Our ref: PS124347-GEO-LTR-001_final

Review of Geotechnical Report - Proposed Residential Development, 89 John Whiteway Drive, Gosford, NSW

Figure 4.1 Locations of boreholes and test pits (extracted from JKGeotechnics' report)

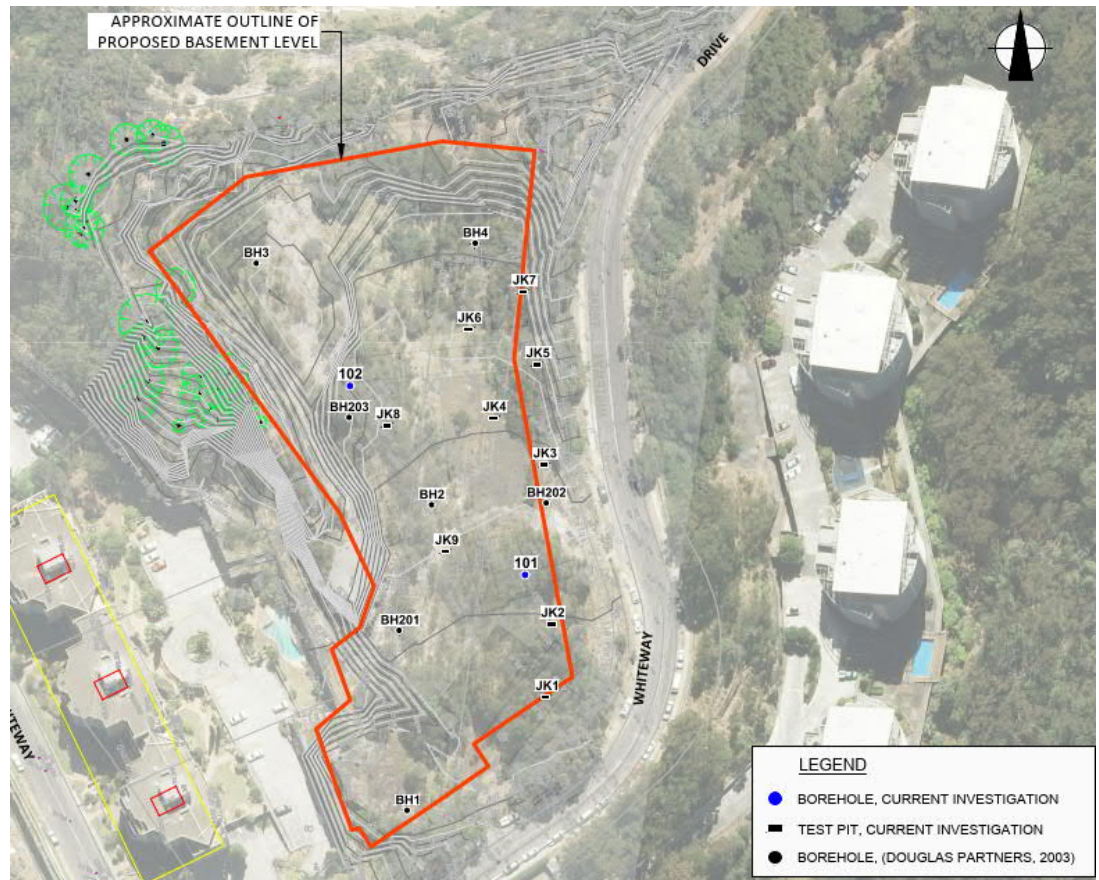
Scale of site investigation: All of boreholes and test pit logs show consistent subsurface profiles across the site: fill comprised of gravelly silty sand or silty sand up to depths from 0.25 m to 1.3 m over medium to high strength sandstone bedrock. Historical boreholes and additional site investigation presented in the report indicate that there are no significant variations of the subsurface conditions identified across the site, therefore, it is considered that the scale of site-specific geological investigation is appropriate for the project stage of development application.

Figure 5.1 Vehicle access ramp to be constructed close to cliff

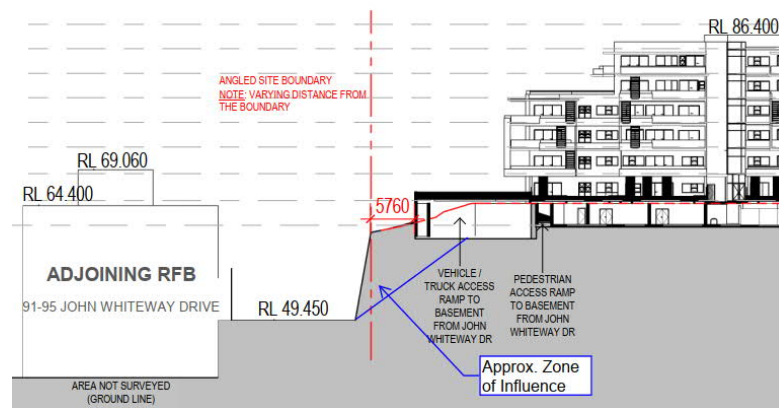
It is noted that slightly deeper excavation is proposed at Block A for vehicle/truck access ramp to the basement from John Whiteway Drive with less than 6 m to the boundary and cliff (Figure 5.1). It is recommended that following actions to be taken to ensure the stability of the cliff at this location

- The design of foundations, if any, should have loads be transferred down to the zone of influence.
- Geotechnical engineer to inspect the exposed rock face to identify any potential rock wedges and advised protection measures.

Figure 5.3 Deep cut in rock up to 10 m on headland rocks

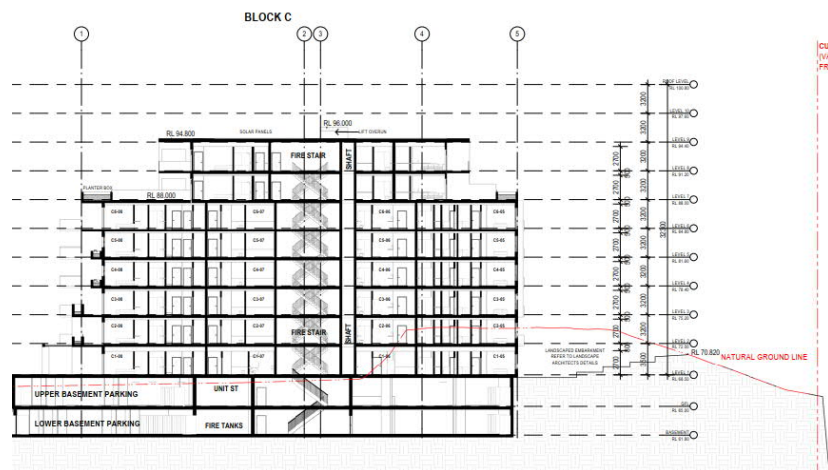
As indicated in The Report, the rock exposed in the headland is mainly sandstone but with bands/lenses of fragmented shale and the eastern face of the headland has been benched as it would not form stable vertical faces. No site mapping has been done for the headland outcrops (Figure 5.2). It is noted that over 10 m cut would be required as shown in Figure 5.3 below. Saw cut or hammering could induce unstable outcrop if there are defects to form rock wedges.

- Site mapping on the faces of headland (based on accessibility) to be carried out prior to construction to identify any potential rock wedges.
- Reassess the Baker Ryan Stewart detailed rock catcher fence (Figure 5.4); if rock wedges are identified, then additional measures may be required.
- Geotechnical engineer on site during construction to inspect the exposed rock faces and provide support/reinforcement advice if necessary.
